TECHNICAL BULLETIN**Z04 pads for M4 calipers SUPERSESSION**

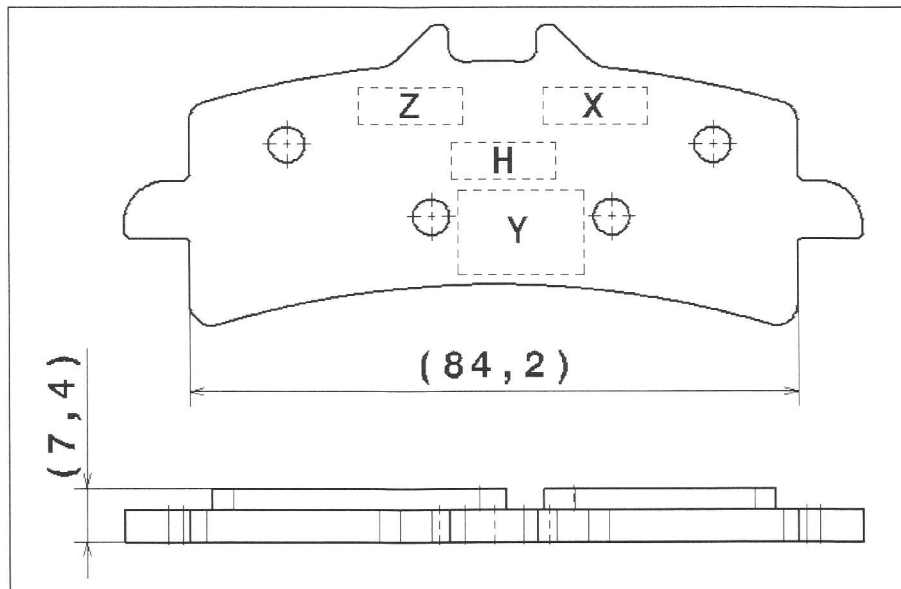
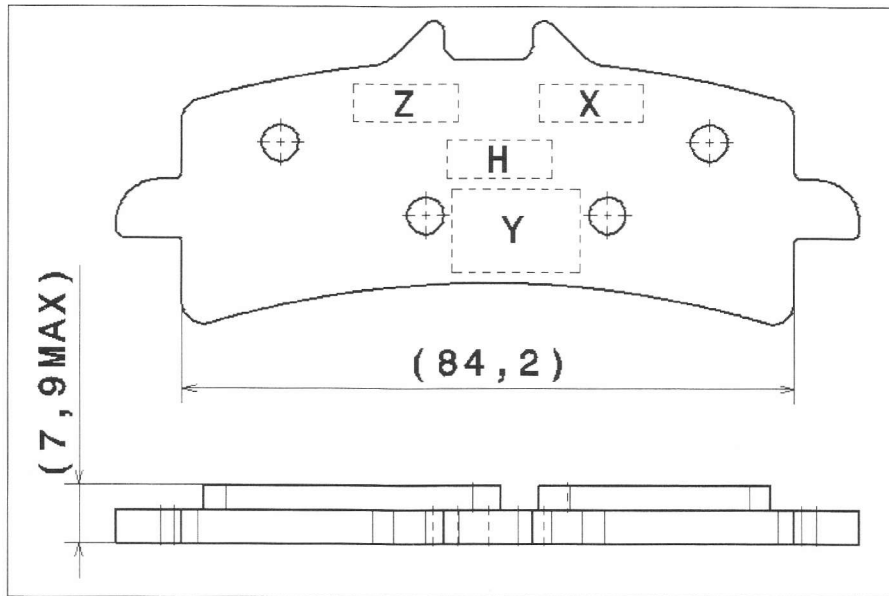
we would like to inform you that the Z04 pad kit 107A48649 has been superseded by the new **107A48639**;

The kit 107A48649 is no longer available in stock;

1) **107A48649** Z04 pad KIT (2 pads included)

- Pad total thickness: 7,4 mm;
- Back plate thickness: 4,8 mm;
- **Usable material: 2,6 mm;**

2) **107A48639**

Z04 pad KIT (2 pads included)

- Pad total thickness: 7,9mm;
- Back plate thickness: 4,5mm;
- **Usable material: 3,4 mm;**
